Delegated Report

Householder Planning Application

Planning Application No: 20221340

Description: Retention of boundary wall and proposed drop kerb

*Drawing number 224SR PO1 measures 15.24 metres whilst,
Drawing number 224SR Site measures 14.70 metres*

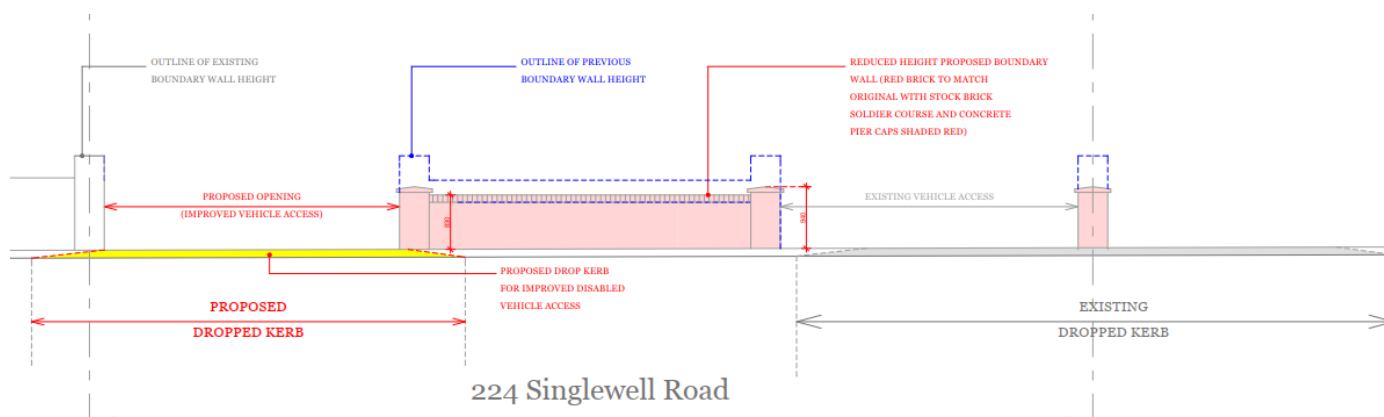
I note the applicant is disabled and whilst it is desirable to ensure he is not disadvantaged, his tenure is temporary however long and so it is essential to ensure road safety is not compromised.

During 2022, Kent County Council revised their requirements for carriage crossovers and in particular subject to certain conditions being met are more receptive to allowing separate entrances and exits being constructed.

- 1. Will the provision of an additional access result in a significant impact of on street parking. In this location, the answer would be no impact, as all properties have off street parking available.*
- 2. The front garden must measure at least 15 metres wide by 4 metres deep. Whilst the depth of the garden is significantly more than the 4 metres required, I measure the width as less than the 15 metres required by Kent County Council (although it depends on which drawing used). Whilst the difference may only be some 300mm, it is sufficient to recommend refusal as to permit the application would set a precedent and make a nonsense of the guidance issued by Kent County Council.*

The drawings should be dimensioned to ensure consistency.

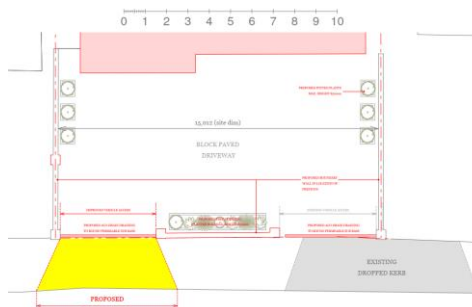
The proposal seeks retention of a boundary wall and proposed drop kerb. The boundary wall has a maximum height of 9.4m and a width of approx 5.7m.

The proposed dropped kerb will serve a second access point and will be situated on the northern side of the development.
